Report: TAB Report
Function: Test, Adjust, & Balance
Date: 03/09/2026
Completed By: National TAB

PROJECT
03-09-26 QT #0472 PEORIA, AZ

8293 W LAKE PLEASANT PKWY

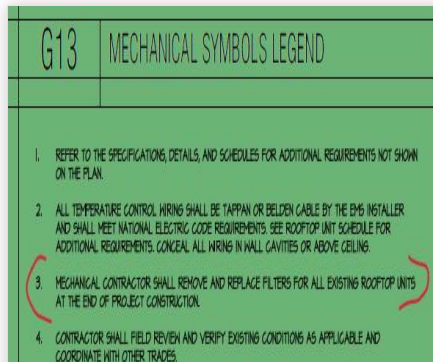
Issue Name : DIRTY FINAL FILTERS
Description : MSET states mechanical contractor should replace filters at project's culmination. Filters don't appear to have been changed and are extremely dirty.
Created By : National TAB **Assigned To :** National TAB - Dan Hertenstein
Status : Open
Priority : Low **Asset Tag :**
Originated Date : 03/10/2026 - Christine Weale - National TAB

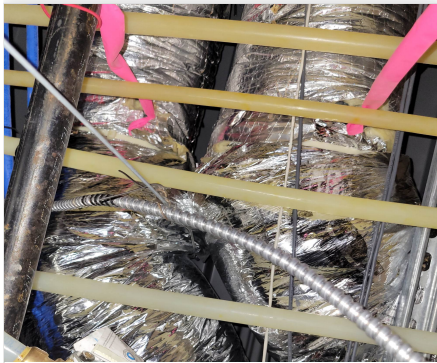
Issue Name : RTU3 POSSIBLE ACTUATOR ISSUE
Description : Econ damper didn't seem to be functioning properly or responding appropriately to settings. Even on 15.0 Emerson setting, damper wouldn't open as the others did. Had to set the Belimo actuator to 0.3". At first, it wouldn't fully open to 46.0 as the others did, either. Manually set to balance.
Created By : National TAB **Assigned To :** National TAB - Dan Hertenstein
Status : Open
Priority : InfoOnly **Asset Tag :** RT-3
Originated Date : 03/10/2026 - Christine Weale - National TAB
